Application Number: PL/25/0008

Location: 45 Caversham Road, Reading

Proposal: Application for Approval of Details Reserved by Condition 22 (Refuse and Recycling)
of application 201420

Condition 22: (Refuse and Recycling)

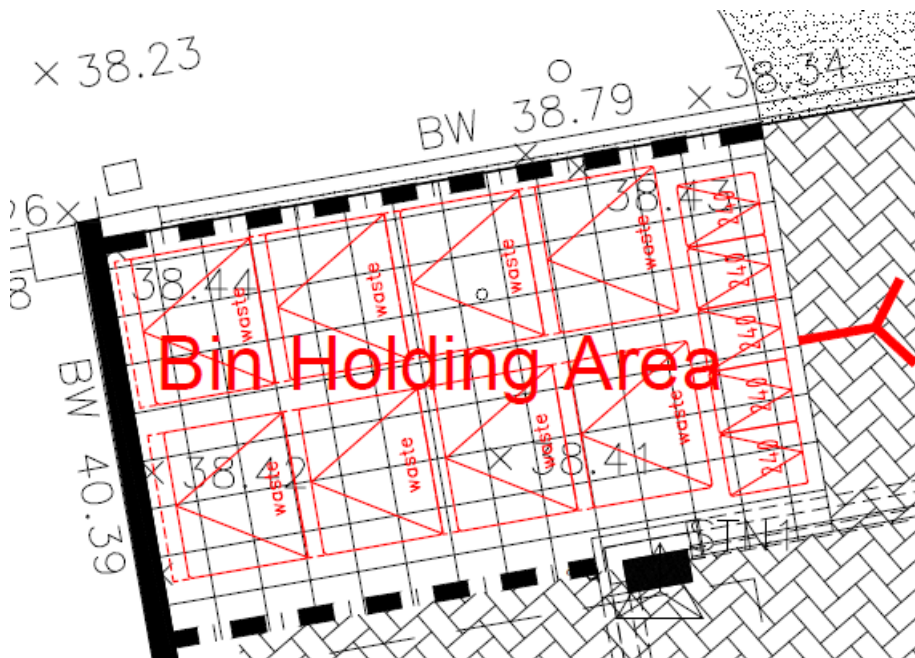
Please be aware that food waste is collected by a separate vehicle to that of the recycling/general waste. It is important to ensure that the food waste bins do not obstruct access to the other bins in the bin holding area – as shown on the plan below –

It would be better for the food waste bins to be stored along the side of the holding area, rather than blocking the front.

We will need access through the gate to be able to retrieve the bins from the holding area. If locks are to be fitted to any doors or gates at bin storage areas, these should be either combination or keypad style with a code. Developers and site managers should be aware that the code will be held within our collection records and shared with a number of collection staff to ensure ease of access. Individual patterned, physical keys or security fobs will not be accepted or permitted. All arrangements must be agreed with Reading Borough Council prior to installation.
